DOE-0226-05

**RESPONSE TO COMMENTS FOR THE OPERABLE UNIT 4 COMPLEX SILOS 1&2
COMPONENTS 34A (SILO 2), 34b (SILO 1) AND SILOS 1&2 BRIDGES
IMPLEMENTATION PLAN FOR ABOVE-GRADE DECONTAMINATION AND
DISMANTLEMENT**

**OPERABLE UNIT 4 (OU4) COMPLEX SILOS 1 & 2 IMPLEMENTATION PLAN
FERNALD CLOSURE PROJECT RESPONSE TO USEPA COMMENTS FOR THE
COMPONENTS 34A (SILO 2), 34B (SILO 1), AND SILOS 1 & 2 BRIDGES ABOVE-GRADE
D&D PLAN**

FIGURE 1-1 Components 34A, 34B and Silos 1&2 Bridges PCN2

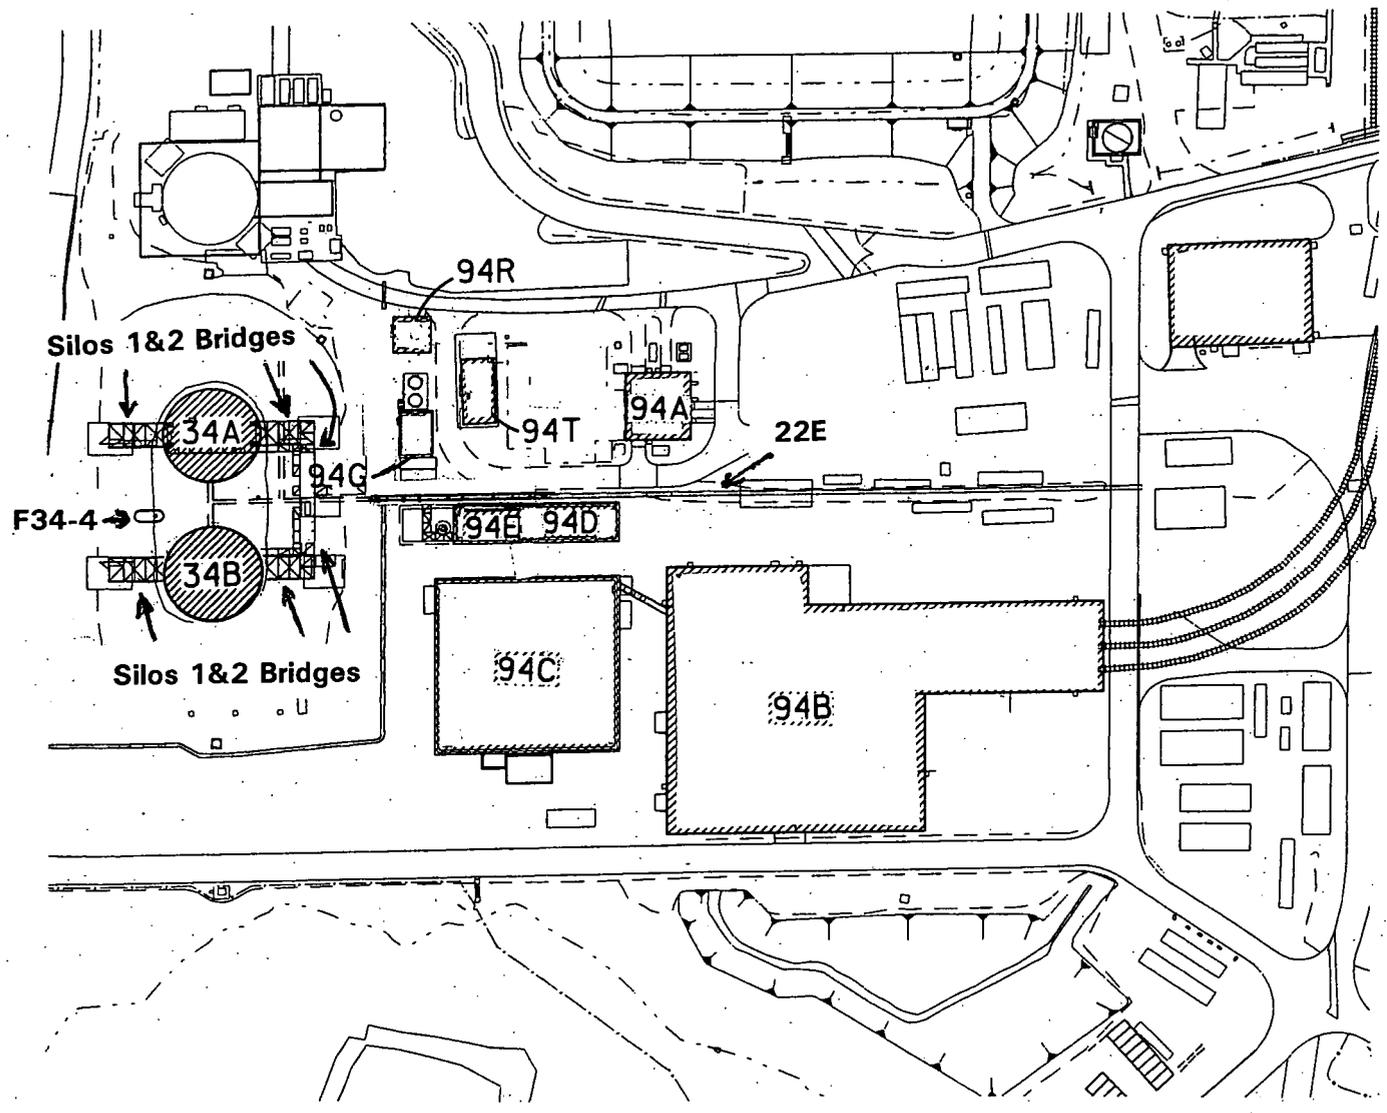
Comment: The text states that the Operable Unit 4 (OU4) components consist of Silo 1, Silo 2, the Silo 1 and 2 bridges, the K-65 Trench, and the Decant Sump Tank. All of these components should be shown and labeled in Figure 1-1.

Comment: Figure 1-1 should be revised to show and label the Silo 1 and 2 bridges, the K-65 Trench, and the Decant Sump Tank. Also, the figure should be revised to indicate the nature of Buildings 94A, 94B, 94C, 94D, 94E, 94G, 94R, and 94T.

Comment: The text discusses the concrete trench and steel piping system of the K-65 Trench. The K-65 Trench and its components should be shown and labeled in Figure 1-1.

Response: Figure 1 has been revised to identify the Silos 1&2 Bridges, the K-65 Trench and the Decant Sump Tank.

Response: Figure 1 has been revised to identify the Silos 1&2 Bridges, the K-65 Trench and the Decant Sump Tank. Figure 1-1 labeling of Buildings 94A, 94B, 94C, 94D, 9E, 94G, 94R and 94T was done to provide a clear layout of the Silos area. Since D&D of these buildings will be covered in a future implementation plan, indicating the nature of these buildings is not necessary in this implementation plan.

Response: Figure 1 has been revised to identify the K-65 Trench.
